## ALERT SERVICE BULLETIN

**412-24-201**

**MODEL AFFECTED:** 412EP

**SUBJECT:** TRANSMISSION ASSEMBLY 412-040-008-105,  
UPGRADE OF

Figure 1 (Sheet 1 of 2). Transducer and connector replacement.

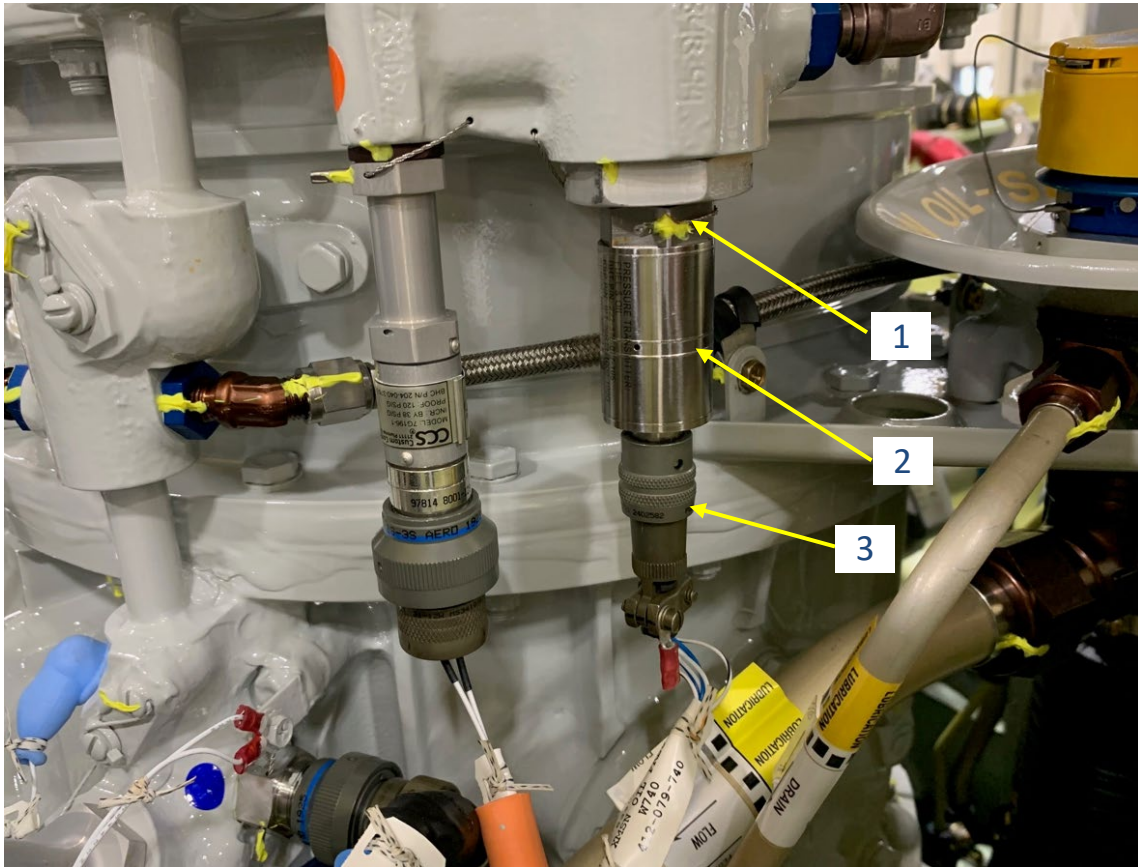
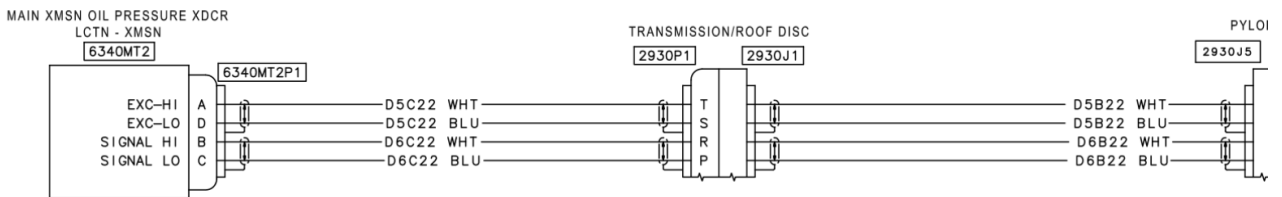
**PART I** of this bulletin mandates the replacement of the currently installed 222-375-077-105 transducer and 160-027-508 connector by 222-375-077-121 transducer and D38999/26WA35SN connector having an improved locking mechanism.

1. Prepare helicopter for maintenance and remove necessary cowlings to access the oil pressure transducer (2, Figure 1, Detail A).
2. Disconnect connector (3), remove safety wire (1), transducer (2), and the packing.
3. Install new AS3208-04 packing and 222-375-077-121 transducer (2). Torque 50 to 65 in-lbs (5.65 to 7.35 Nm) and safety wire with AS100028 (C-405).
4. Remove existing terminal lugs from the strain relief.
5. Disconnect strain relief from connector (2).
6. Remove wires listed below from the existing connector (2, Figure 1, Detail B).

7. Remove and discard contacts from the end of each wire.
8. Discard existing connector (2).
9. Install new 130-061-6W4MA tubing over the wires.

10. Install new M85049/38-9W strain relief over the wires.
11. Install one of the supplied contacts at the end of each wire and insert in new D38999/26WA35SN connector (2, Figure 1, Detail B).

12. Install new strain relief on new connector (2).
13. Install the two terminal lugs on the strain relief.
14. Locate the data tag showing the harness assembly part number and re-identify the harness assembly as 412-079-740-403 -105FM with a permanent marker.
15. Secure connector (2) to transducer (3).
16. Do an operation check of the transmission oil pressure indicator system per BHT-412-MM, Chapter 96 (DMC-412-A-96-11-00-03A-320A-A).

**Figure 2. Oil jet attaching screw replacement.**

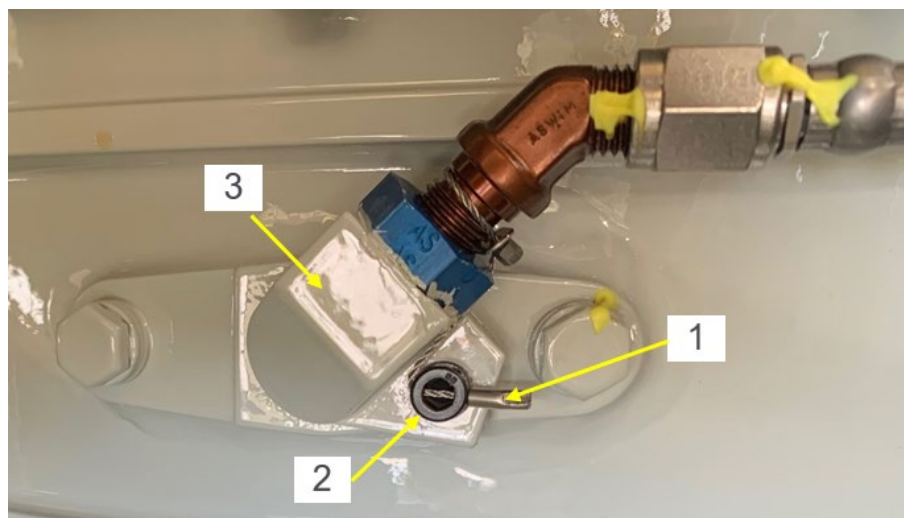
**PART II** replaces MS35266-62 screws securing the oil jets to the housing with NAS1351-3H6 screws with a specified torque.

1. Gain access to ring gear (4, Figure 2).
2. Locate the two oil jets (3) and remove the safety wire (1) and screws (2) (Figure 2, Detail A and Detail B).
3. Ensure the threads in housing (5) and the new NAS1351-3H6 screw threads are clean and free of contamination.

4. Apply Loctite (C-299) to the threads of the screws and install. Torque screws 10 to 18 in-lbs. (1.13 to 2 Nm) and safety wire with AS100028 (C-405).

Figure 3 (Sheet 1 of 3). Oil Filler cap 205-040-136-001 and Adapter FC-3662 Replacement.

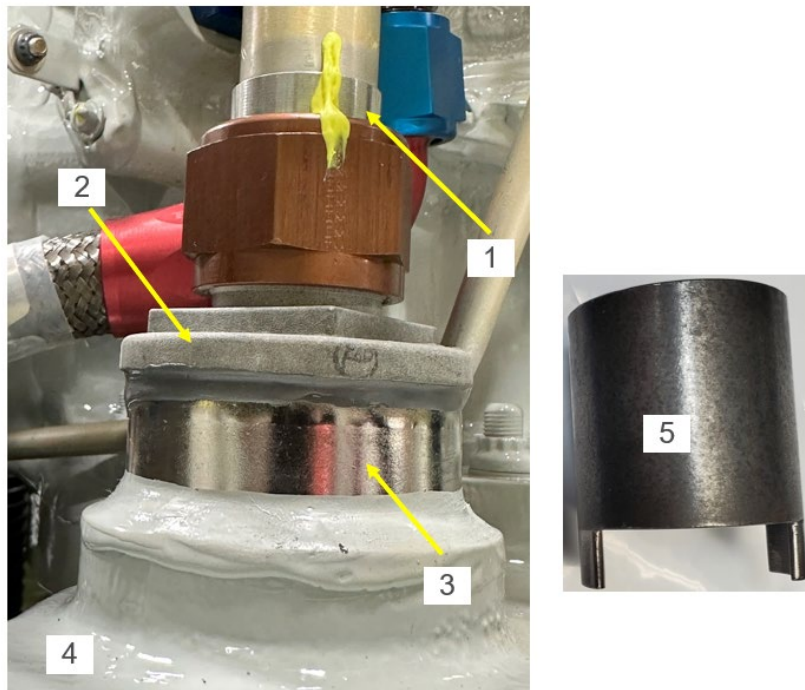
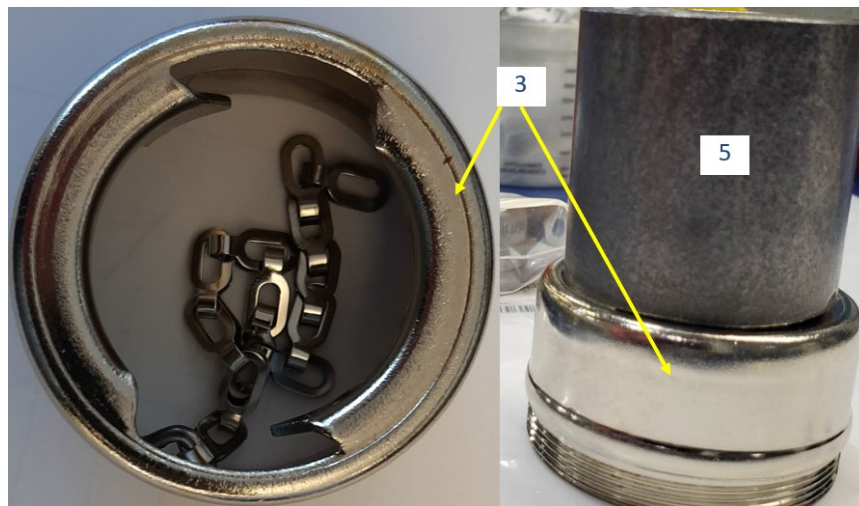
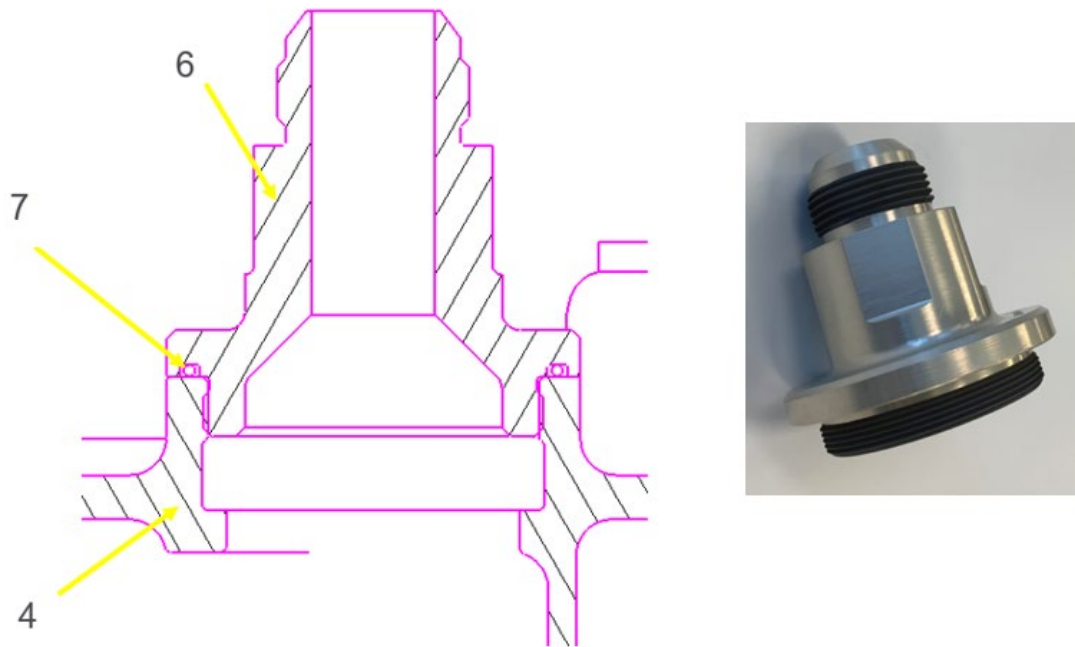
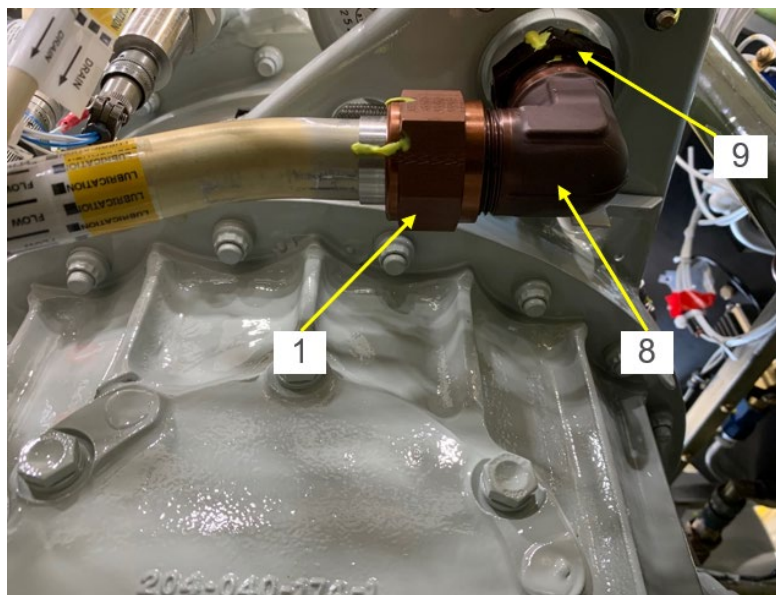
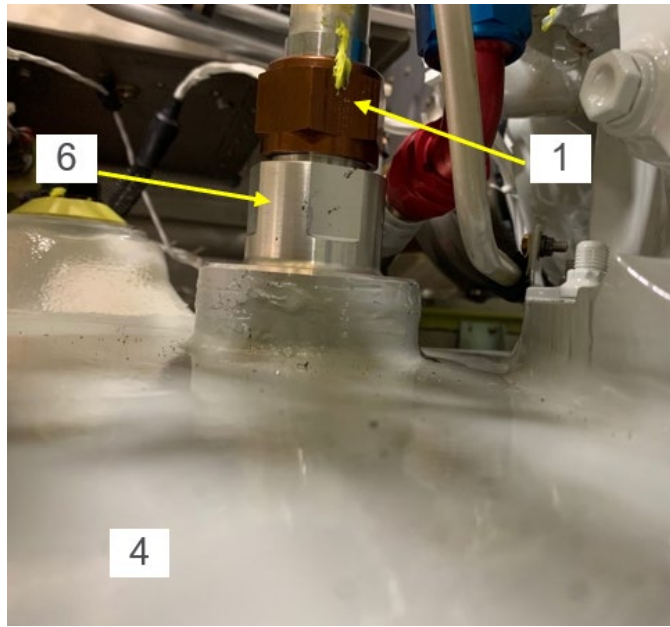
**PART III** introduces a new 412-040-050-101 adapter as a replacement for the 205-040-136-001 cap assembly and FC-3662 adapter installed on the 212-040-054-117 support case assembly.

1. Gain access to cap assembly and adapter (2 and 3, Figure 3).
2. Remove tube assembly (1).
3. Remove sealant around the cap assembly (2) and adapter (3).
4. Remove cap assembly (2).

5. Heat the support case assembly (4), to approximately 200°F ((93°C) and remove adapter (3) using tool (5) or fabricated work aid (Figure 6).
6. Thoroughly clean the threads in support case assembly (4 Figure 3, Detail C) and the threads of the new 412-040-050-101 adapter (6).

7. Install AS3209-142 packing (7) and install adapter (6) into support case assembly (4). Torque 67 to 75 ft-lbs (90.8 to 101.7 Nm).
8. Apply sealant (C-308) at the joint between adapter (6) and support case assembly (4).

9. Install tube assembly (1). To obtain proper fit, elbow fitting (8) may require adjustment. Loosen jam nut (9) and adjust elbow fitting (8) as required and tighten jam nut (10).

**Figure 5. Adapter FC-3662 removal work-aid.**

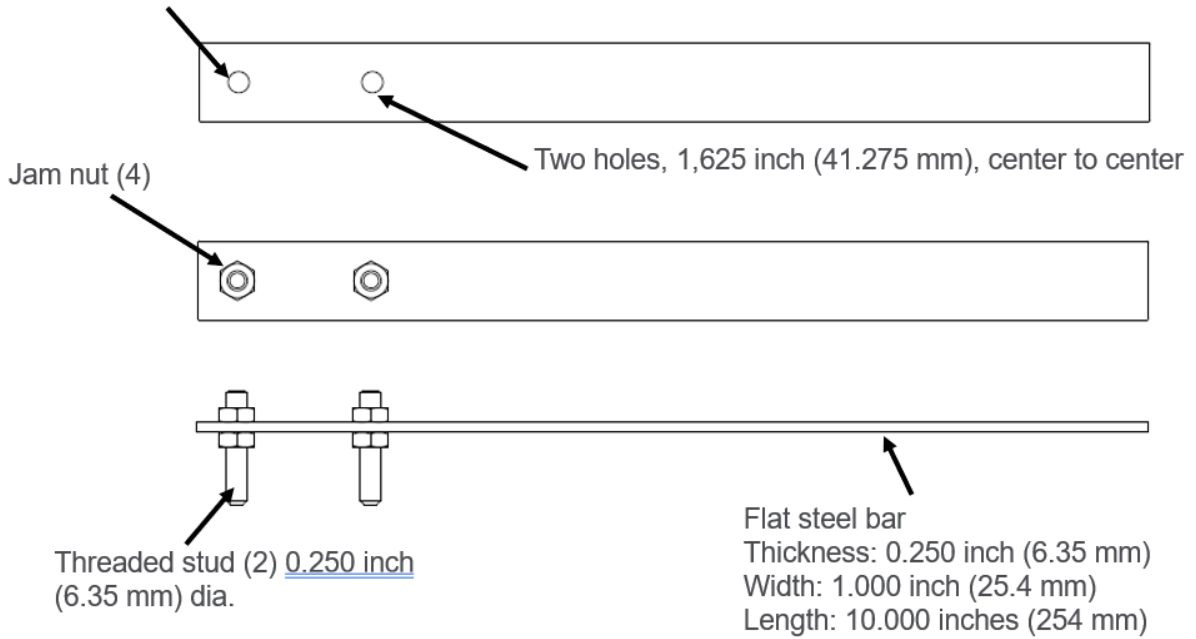
Adapter Tool 204-040-354-009. Locally fabricated work aid can be used as an alternate to remove FC-3662 adapter (Figure 5).
